WOODWARD-CLYDE CONSULTANTS PLYMOUTH MEETING PA  
NATIONAL DAM INSPECTION PROGRAM. FAWN LAKE DAM,  
JUL 78

Fawn Lake Dam, ID Number PA-00693.  
Schuylkill River Basin, Plum Creek,  
Schuylkill County, Pennsylvania.  
Phase I Inspection Report.

PHASE I INSPECTION REPORT  
NATIONAL DAM INSPECTION PROGRAM

PHASE I INSPECTION REPORT  
NATIONAL DAM INSPECTION PROGRAM  
FAWN LAKE DAM  
NATIONAL ID #PA 00693  
DER ID #54-175

SEEPAGE LOCATION PLAN  
 FAWN LAKE DAM  
 SHEET 5a OF 11

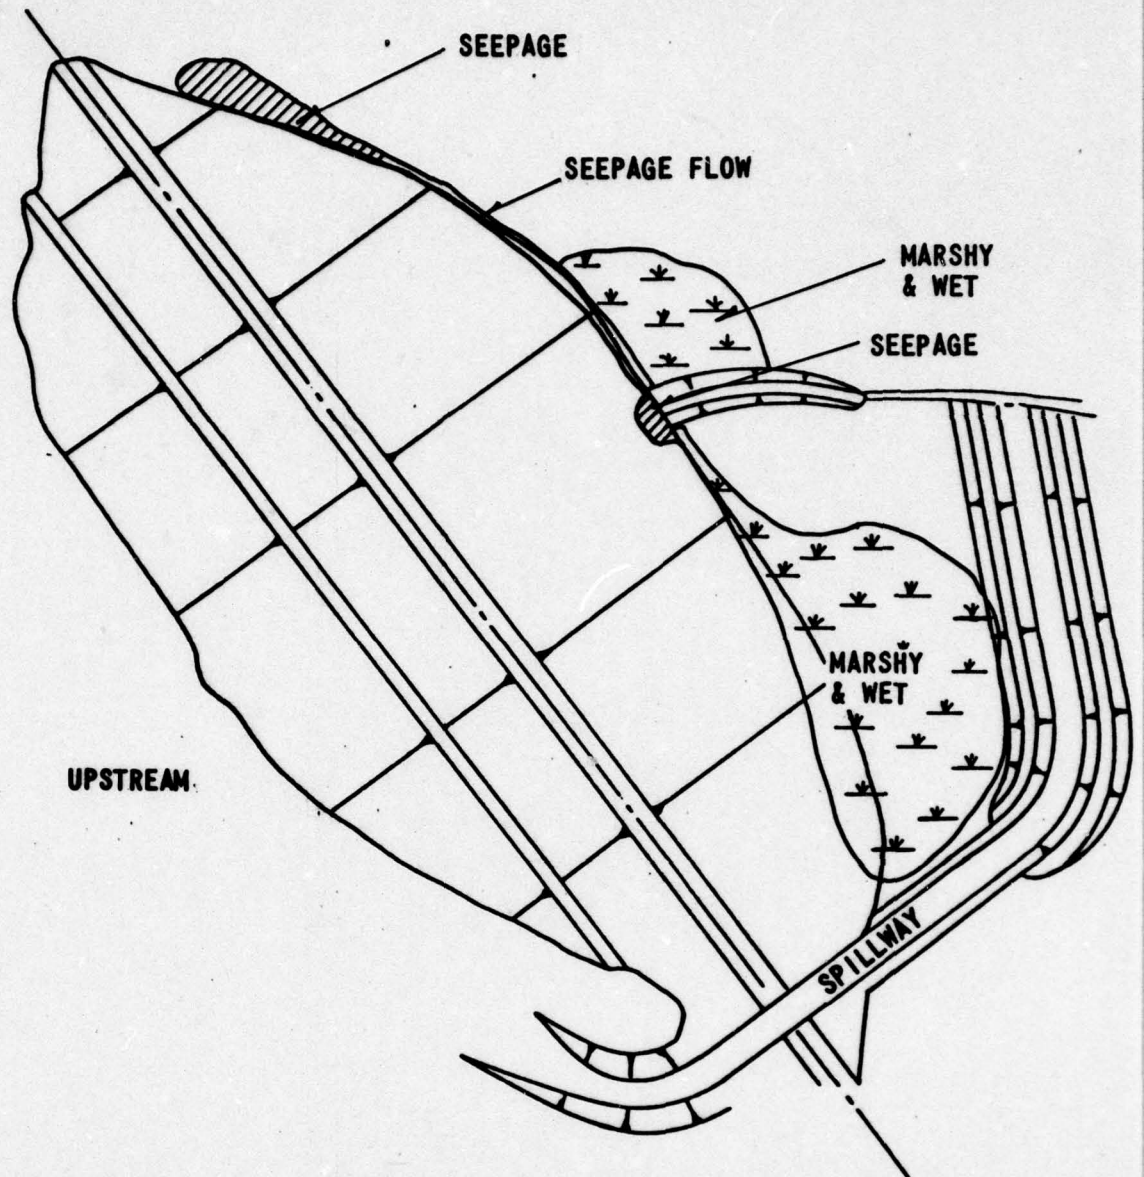
b. Dam. During the visual survey, there were no indications or evidence observed of distortions in alignment or grade that would be indicative of movement of the embankment or foundation. There were no surface cracks or misalignment observed. Some settlement (10 ± inches) of backfill around the concrete spillway chute was noticed. No significant erosion was observed. The riprap was in good condition and stable. Seepage was noted along the downstream toe of the embankment and at the left abutment, which was also reported in a DER inspection report made following filling of the reservoir. Wet, marshy areas were observed downstream of the toe. The seepage locations are shown on Sheet 5(a), Appendix B.

*NOTE: Due to the type of seepage occurring, the rate of seepage could not be estimated.*

As discussed in Appendix B, seepage and wet marshy areas were noted. These areas should be monitored for turbidity, erosion and change in flow rates.

PHOTOGRAPH NO. 1

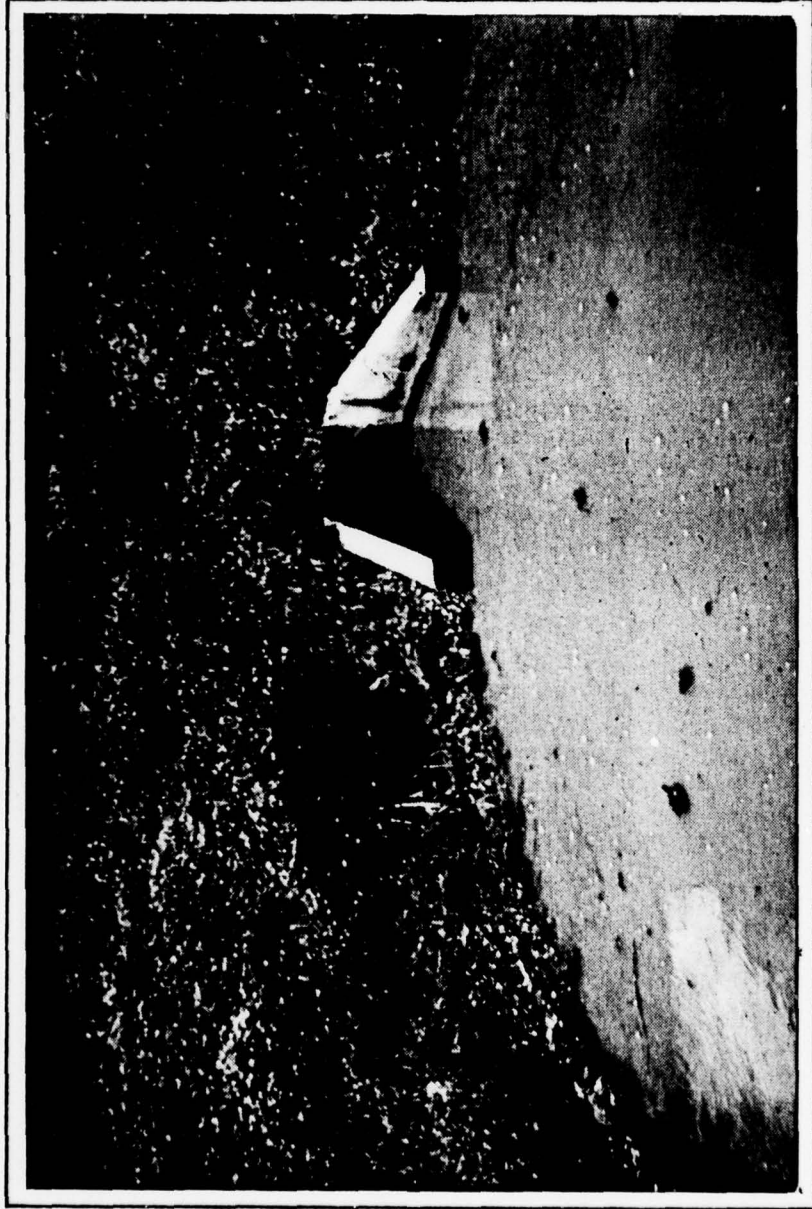
VIEW OF POND DRAIN OUTLET SYSTEM.  
WATER IS MUDDY BECAUSE DRAIN WAS  
OPENED TO TEST SYSTEM.

PHOTOGRAPH NO. 2

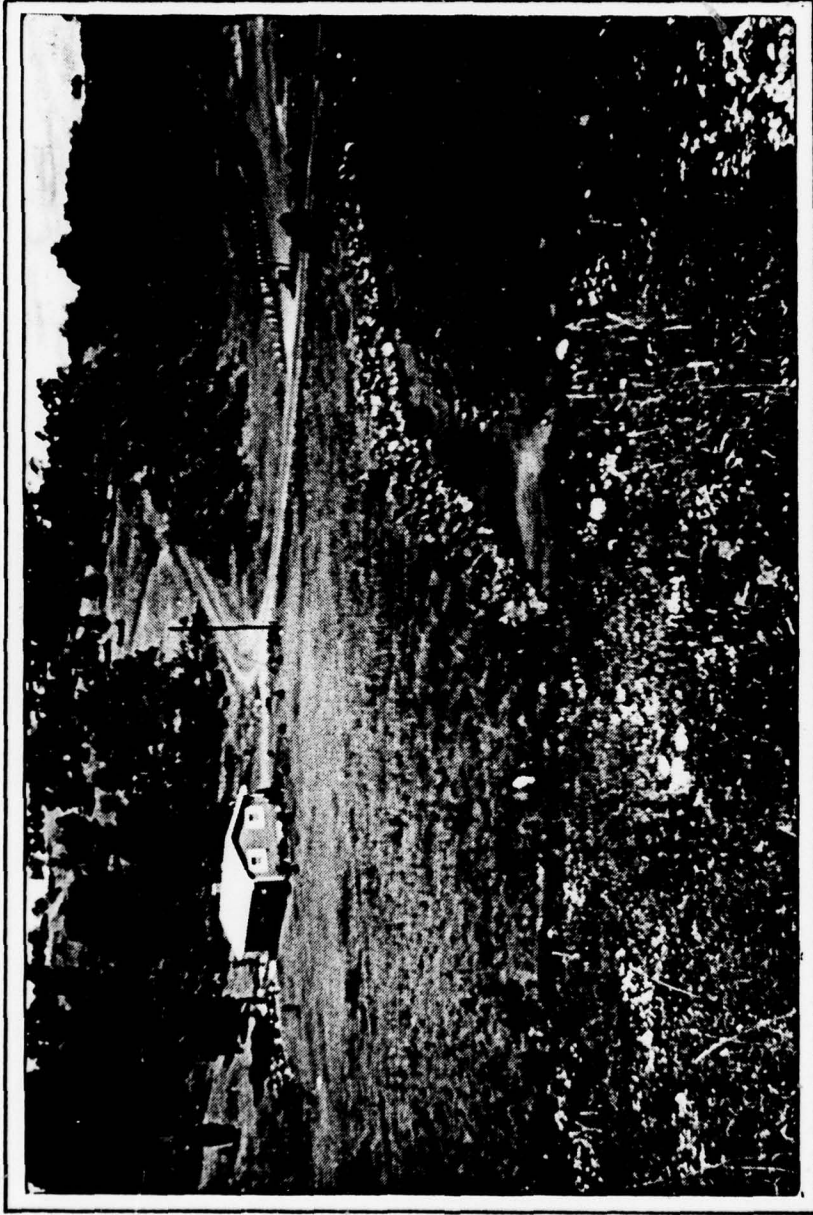
VIEW OF POND DRAIN OUTLET CHANNEL.  
NOTE DISCHARGE UNDER ROADWAY AND  
HOME ON LEFT, SUBJECT TO FLOODING.
